**Statement of Advisory Neighborhood Commission 6C
In Support of Appeal to the Board of Zoning Adjustment
Concerning Permit B2308873**

1. This appeal is taken against the Department of Buildings (DOB) and DOB’s Zoning Administrator, Kathleen Beeton.
2. ANC 6C appeals the issuance of permit B2308873 (“the permit”; copy at Attachment A), issued on February 1, 2024.

3. The permit and this appeal relate to 638 I (Eye) St. NE, aka square 857, lot 125 (“the Property”) in the RF-1 zone.
4. The Property’s owner of record is Kevin R. Chen, 638 I St. NE, Washington, DC 20002.

1 LONGITUDINAL SECTION - A
A300 1/4" = 1'-0"

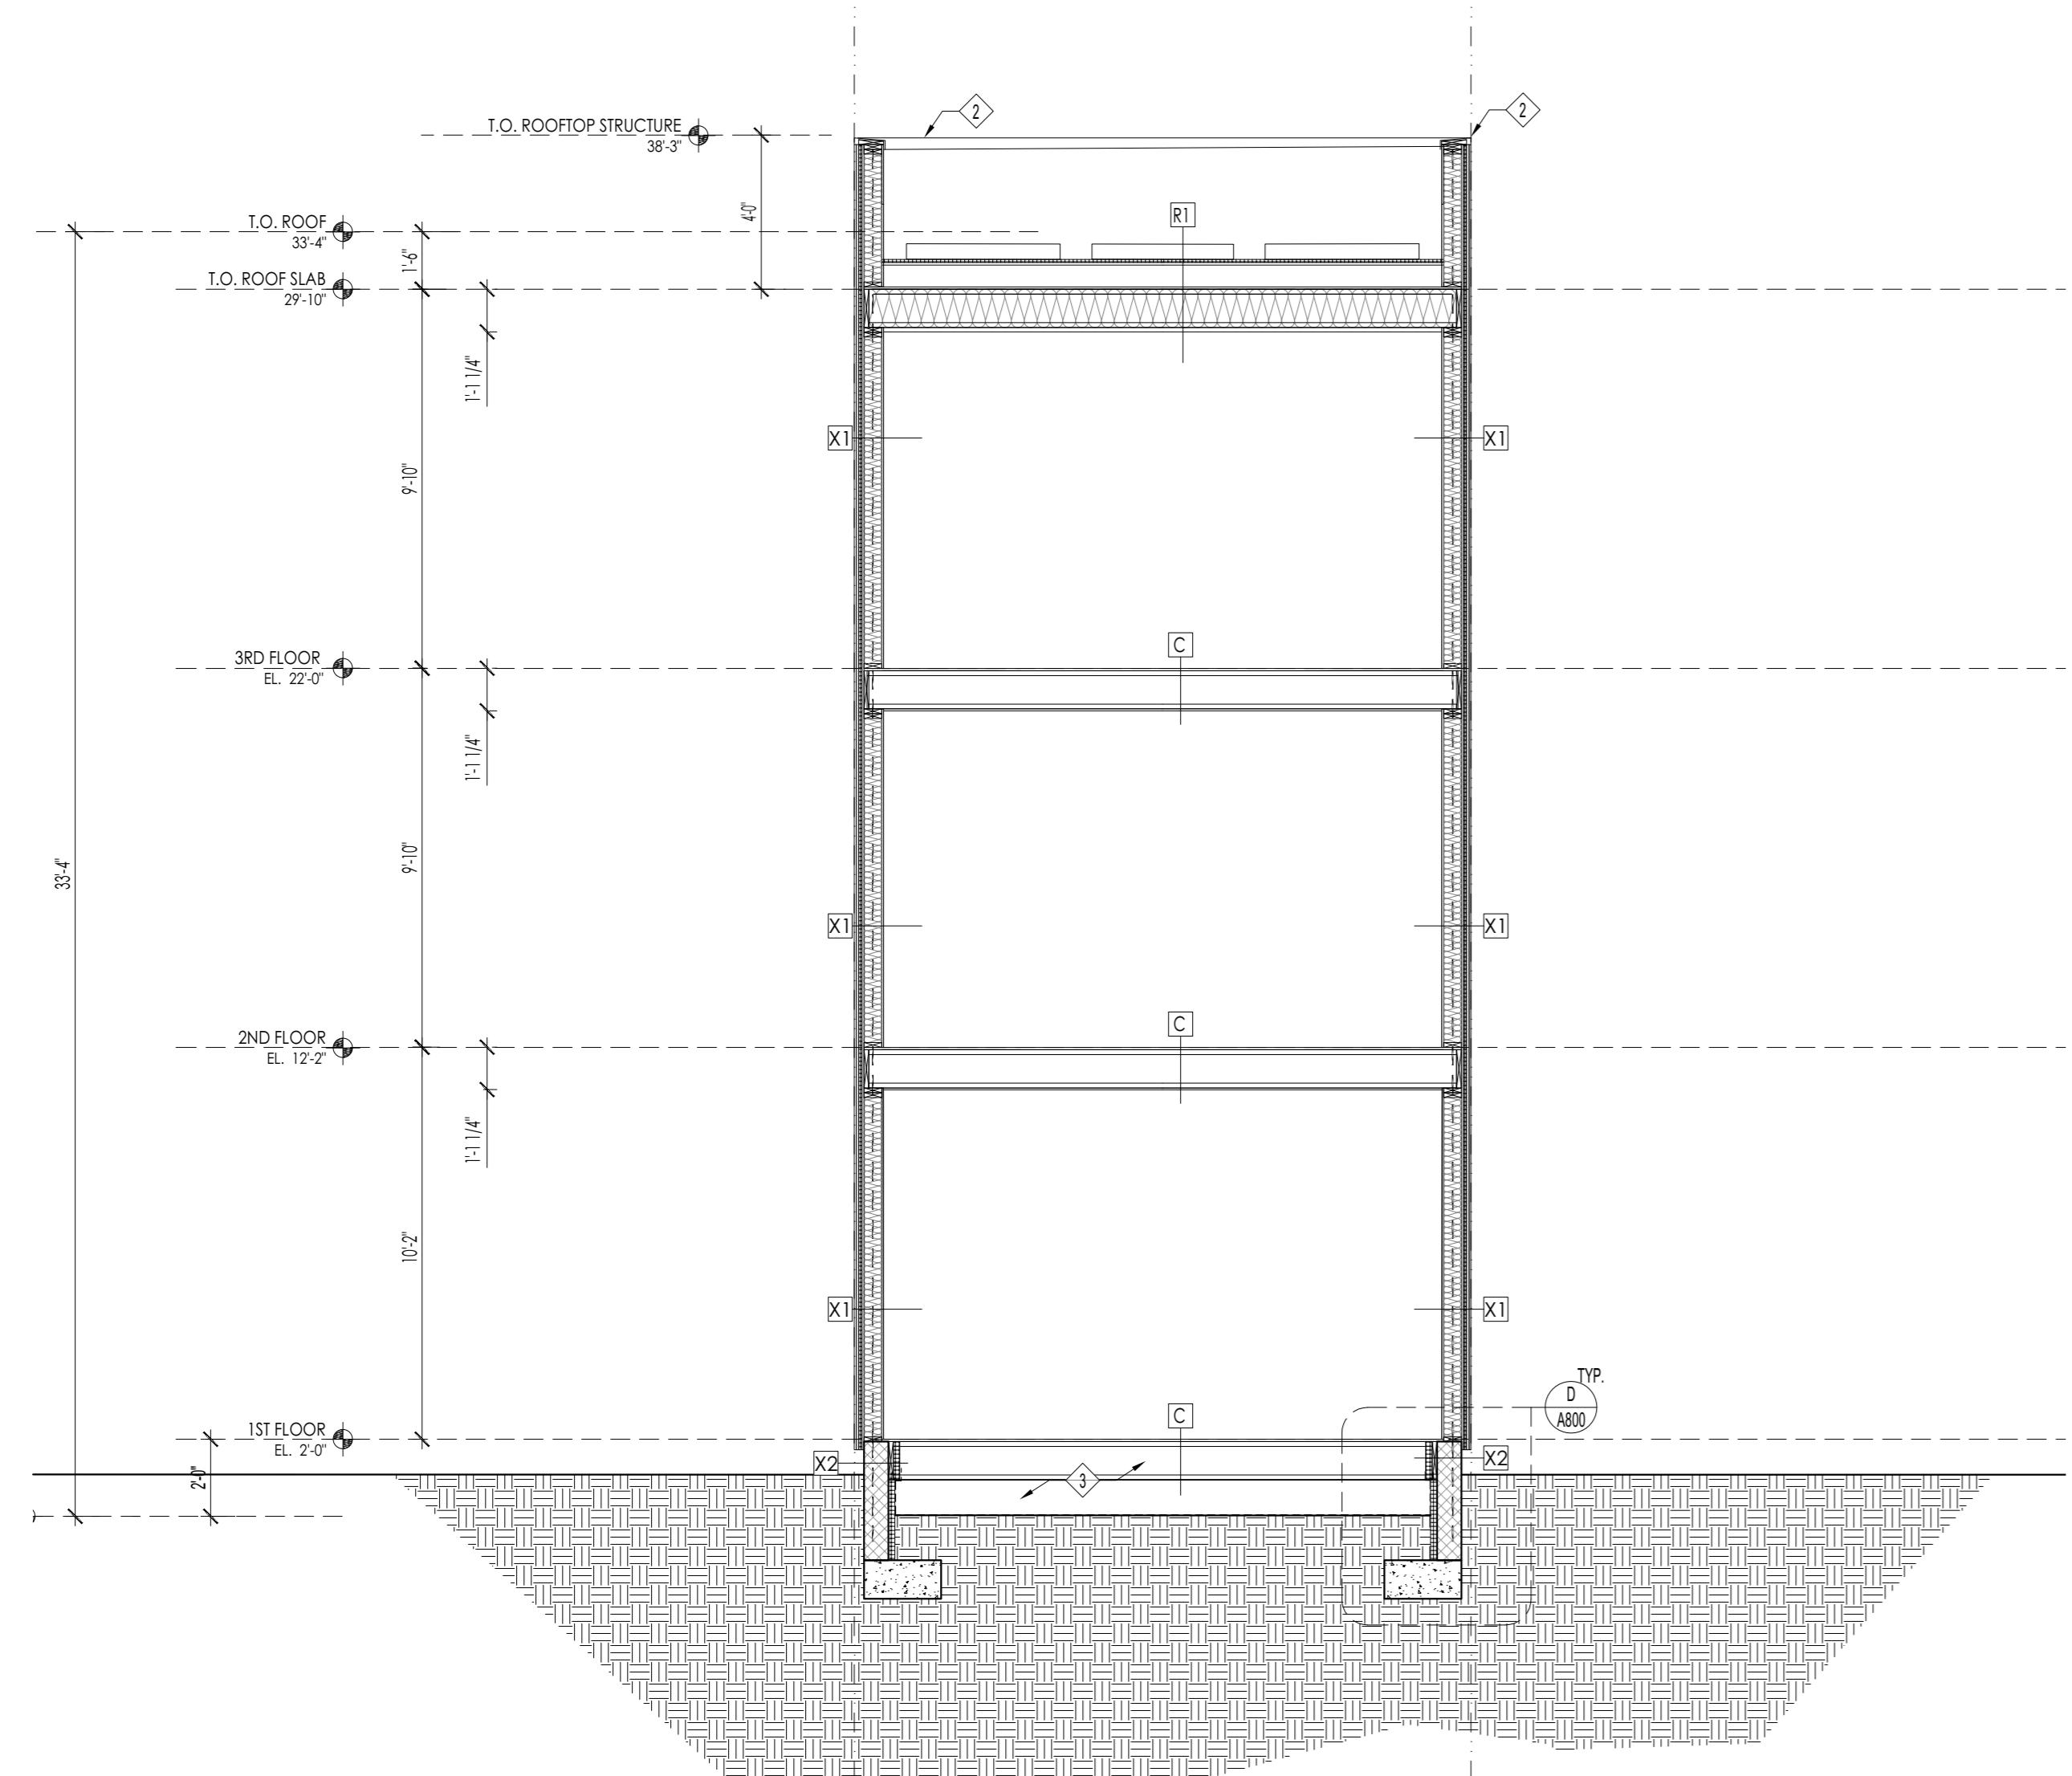
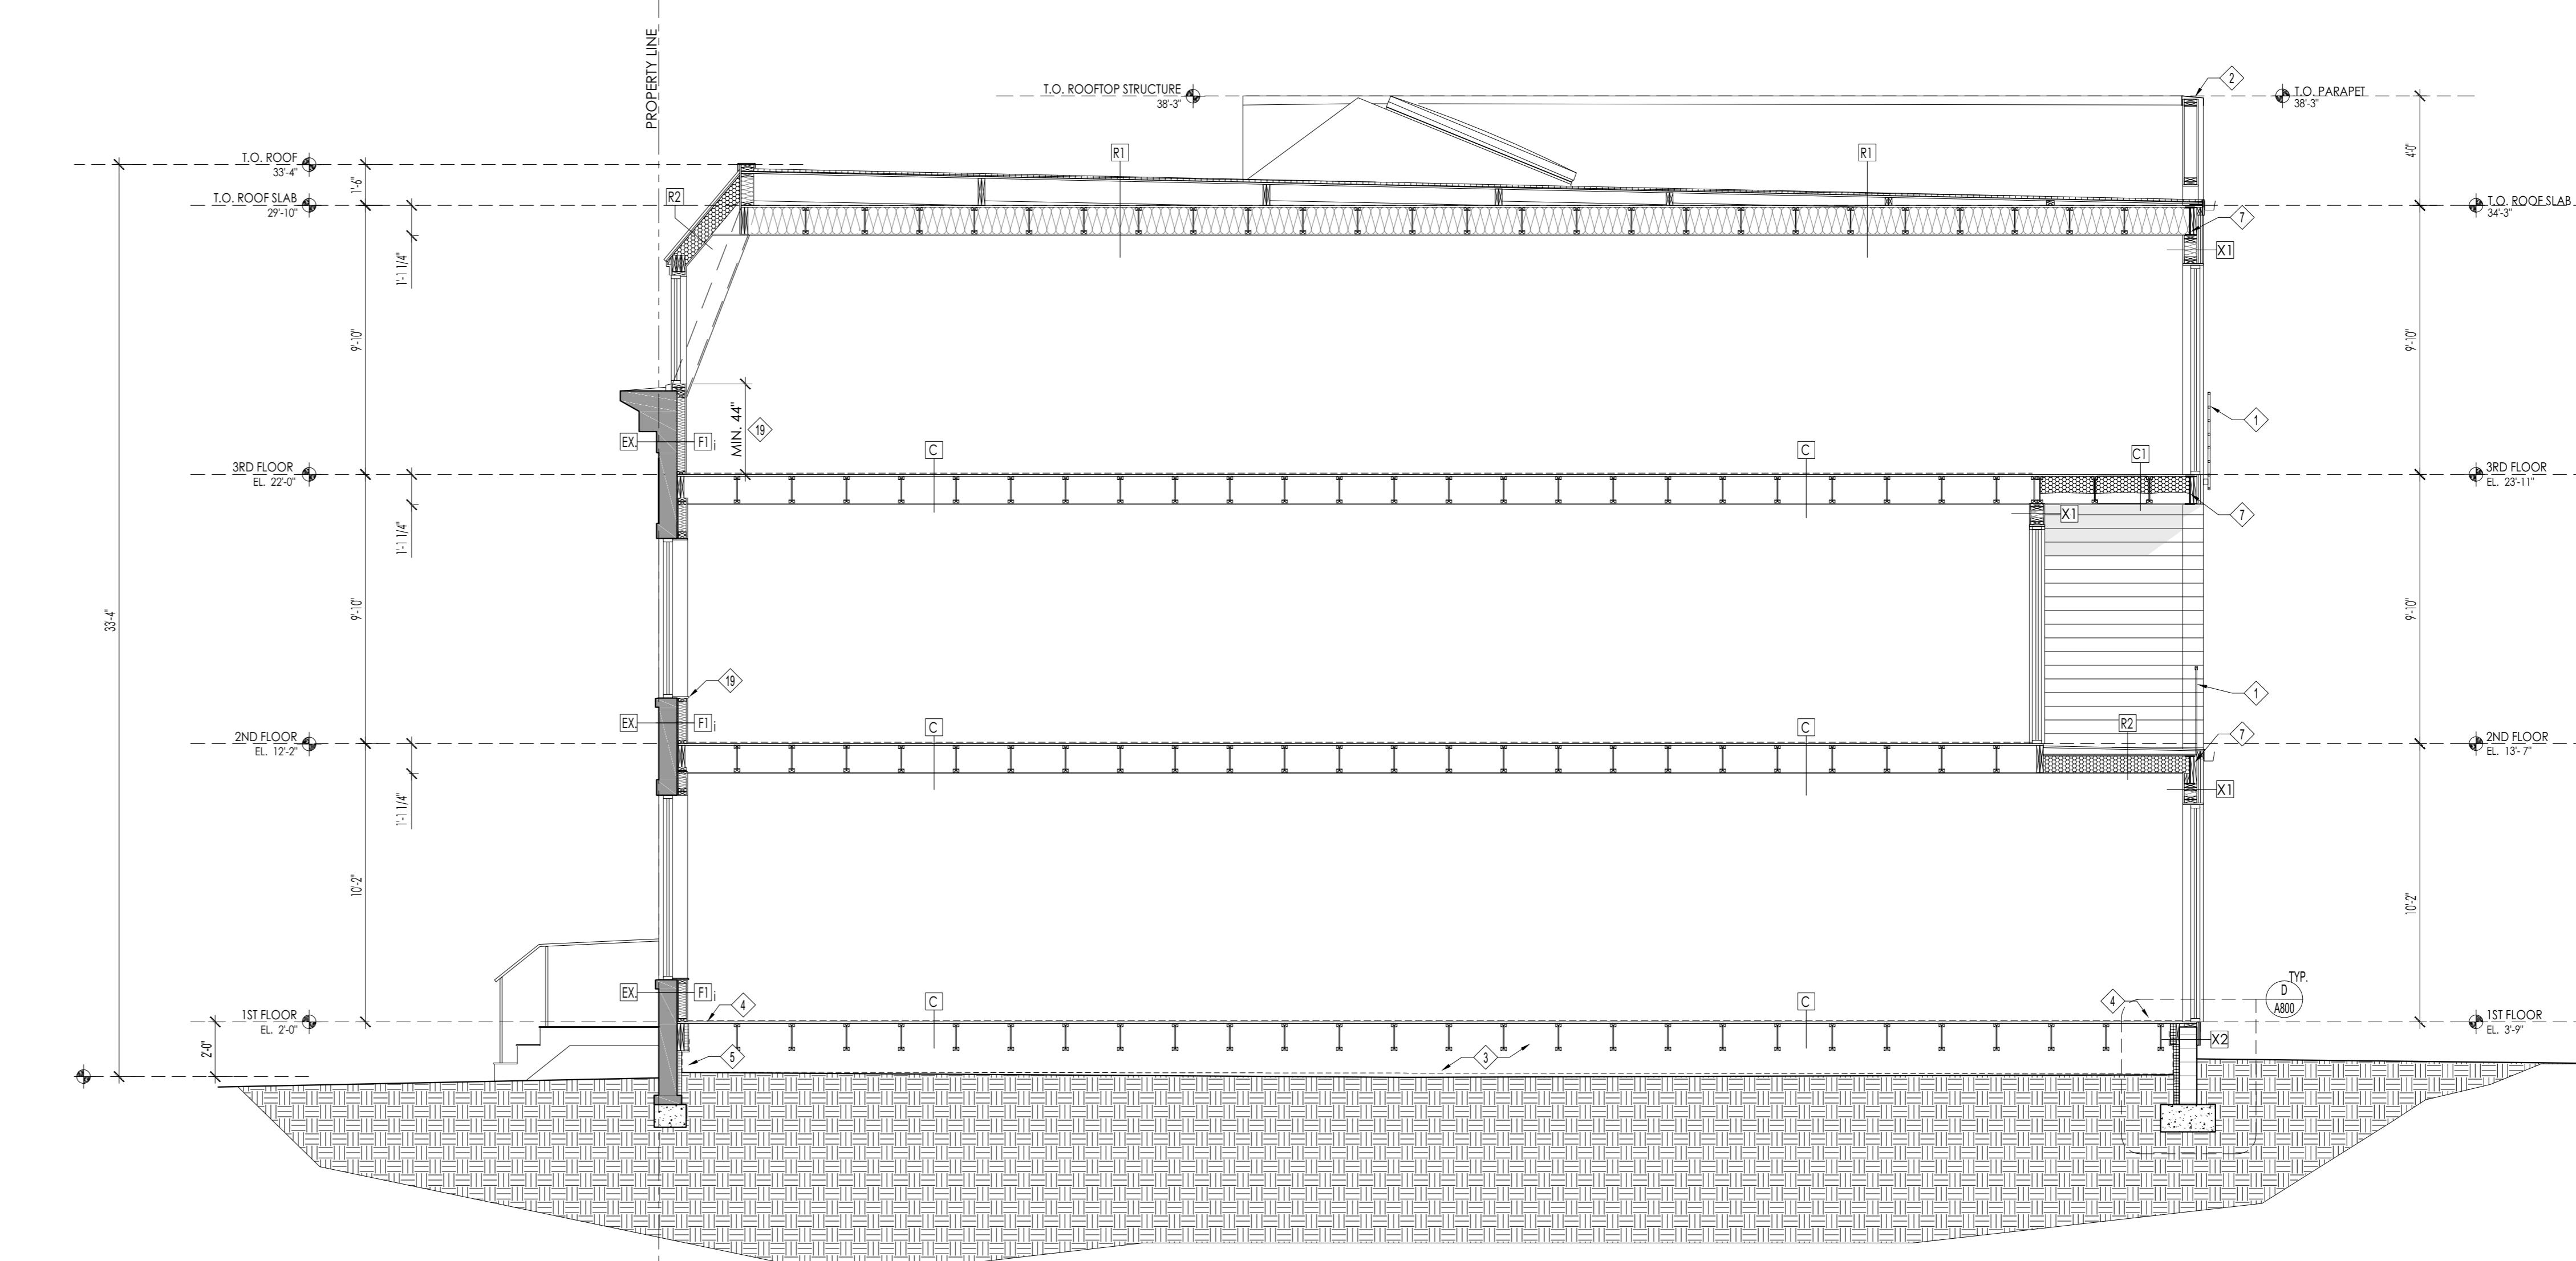
8. Specifically, the permit authorizes construction of an upper-floor addition directly atop an existing cornice—that is, above the cornice in the same plane with no setback.

Please accept this email as a challenge to the issuance of the above referenced building permit. The approved permit drawings are not consistent with the Zoning Administrator's Interpretation 7 regarding required setbacks from protected architecture rooftop elements.

The attached excerpt from the permit drawings depicts a rooftop addition that is coincident with the front facade and cornice, not set back 3 feet. A copy of interpretation 7 downloaded from the DOB website this morning is also attached for reference. Please review and, if you are in agreement, revoke the permit.

Consistent with the past practice under the former Zoning Administrator, a cornice is not a roof-top architectural embellishment and therefore a new addition may be constructed flush with an existing cornice.
